**STATE OF NEW YORK
DEPARTMENT OF PUBLIC SERVICE**

CHANGE NOTICE

SUBJECT: CASE 10-T-0139 - Application of Champlain Hudson Power
Express, Inc. for a Certificate of Environmental
Compatibility and Public Need Pursuant to Article VII
of the PSL for the Construction, Operation and
Maintenance of a High Voltage Direct Current Circuit
from the Canadian Border to New York City.

Notice Number: CHPE-Laydown Yard 1.0-Change Notice 02

Sheet C-203

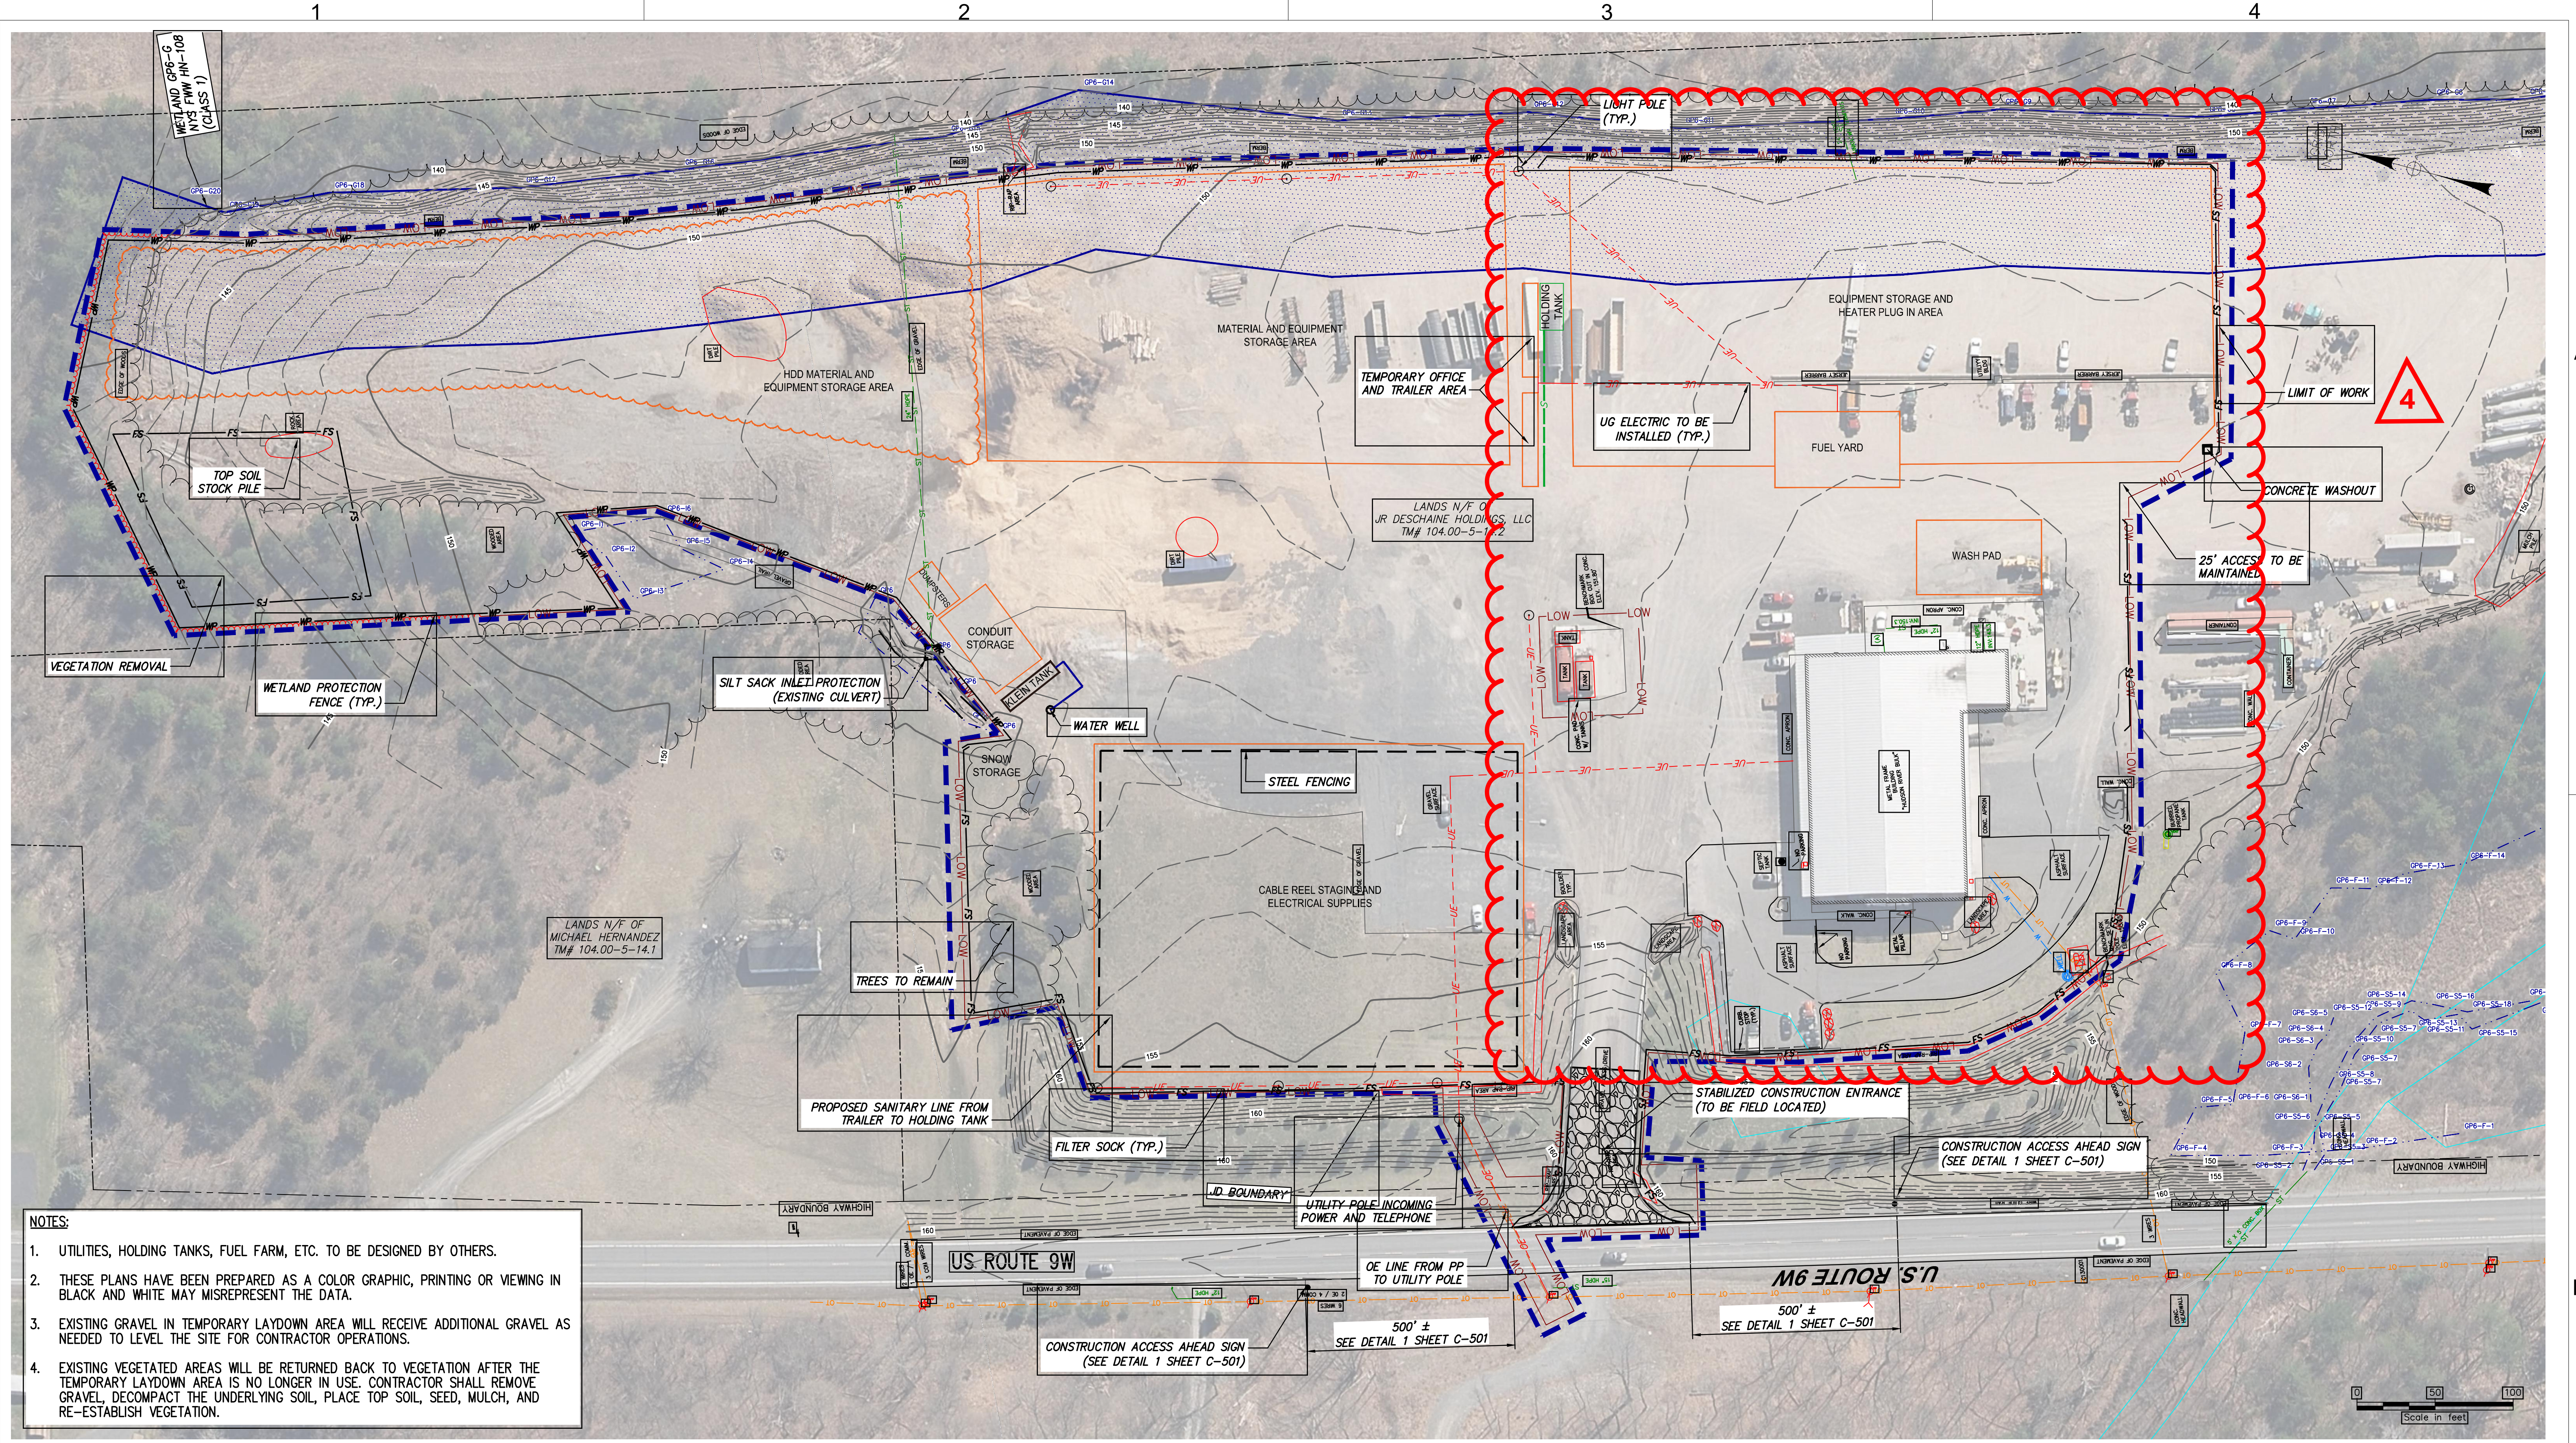
limit of work (LOW) to accommodate an increased area, approximately 5 acres, within the approved Cossackie-Hudson River Bulk Yard. The additional LOW is located adjacent to the southern side of the Cossackie-Hudson River Bulk Yard. This change also involves the to allow the addition of an existing structure, to be used as an office and maintenance facility, and an existing diesel-engine block heating device to promote work during winter months. The Certificate Holder asserts that the additional LOW was reviewed as part of the Laydown Yard EM&CP survey area and contains no regulated resources.

Description of Change: Increase in acreage of Coxsackie-Hudson River Bulk Laydown Yard

This minor change is to increase the Coxsackie-Hudson River Bulk Yard by approximately 5 acres. This additional 5 acres is directly adjacent to the existing southern limit of work for the approved Coxsackie-Hudson River Bulk Laydown Yard (see sheet C-203). This area was part of the approved EM&CP survey area and contains no regulated resources. Within this additional area is an existing structure to be used as an office and maintenance facility, and an existing diesel-engine block heating device that will be employed to ready trucks for work during winter months. The existing fuel tanks located within the additional area will not be employed by the Project and are excluded from the updated Limit of Work.

DPS Staff have reviewed this proposed minor change electronically and, in the field, and believe that it will not result in any net increase of adverse environmental impacts, nor is it directly related to any issues contested during the proceedings. It is recommended that this change be approved, and CHPE be so notified.
